BA COMMENTS - 23/02/15

# 157CHLN\_Basement Cycle Storage Layout - Plan post site visit 03.02.15

This drawing is to be read in conjunction with 157CHLN Site visit report 030215

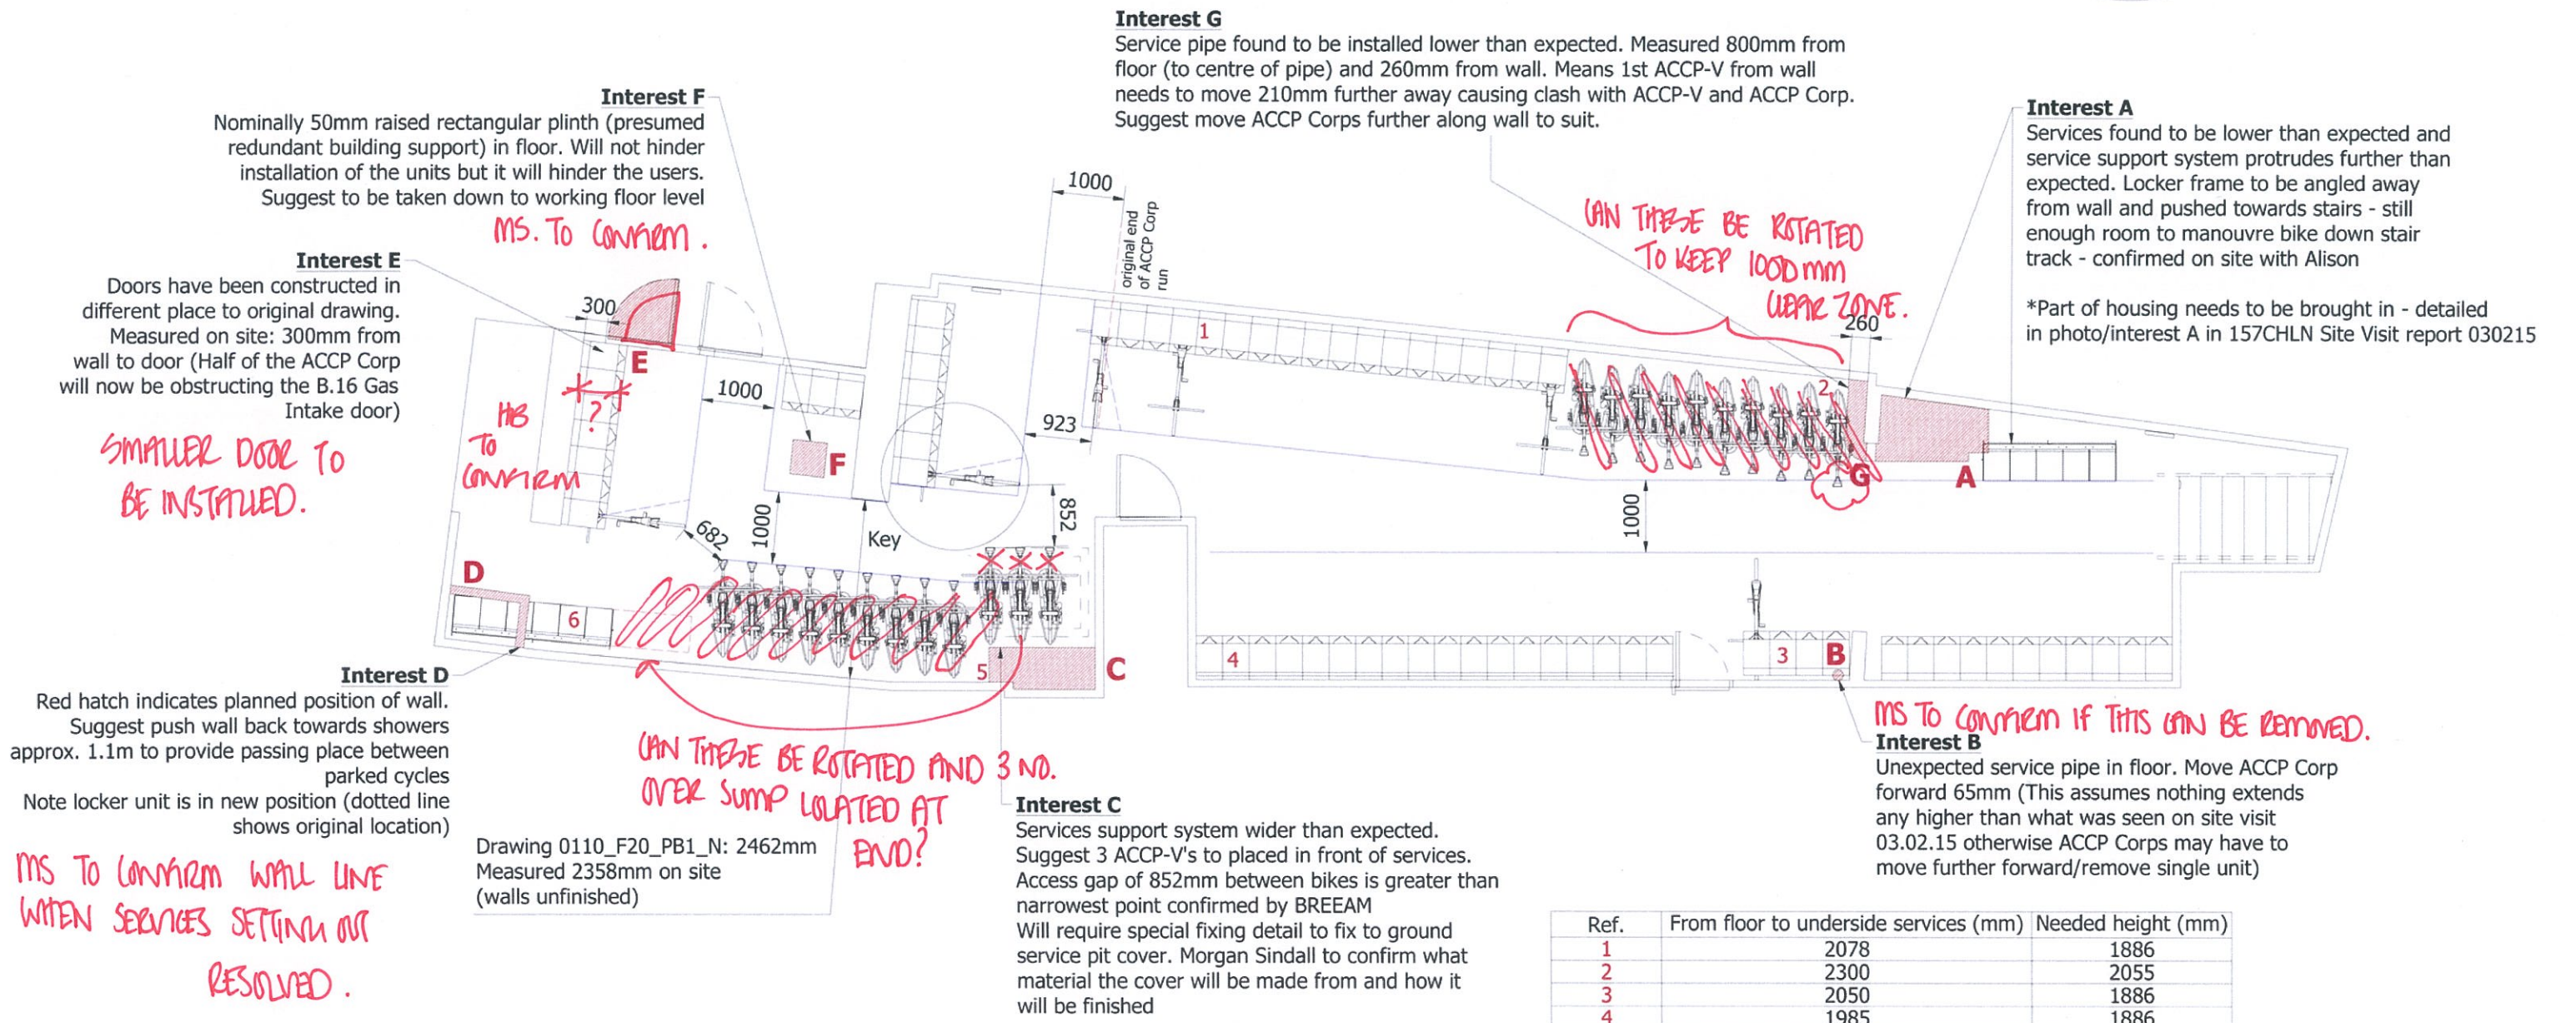
Blushed dashed line indicates line of bike when pivoted around handlebars. Shows that there is more space than perceived

\*\* The part of the product that is this high should sit forward of the services pipework
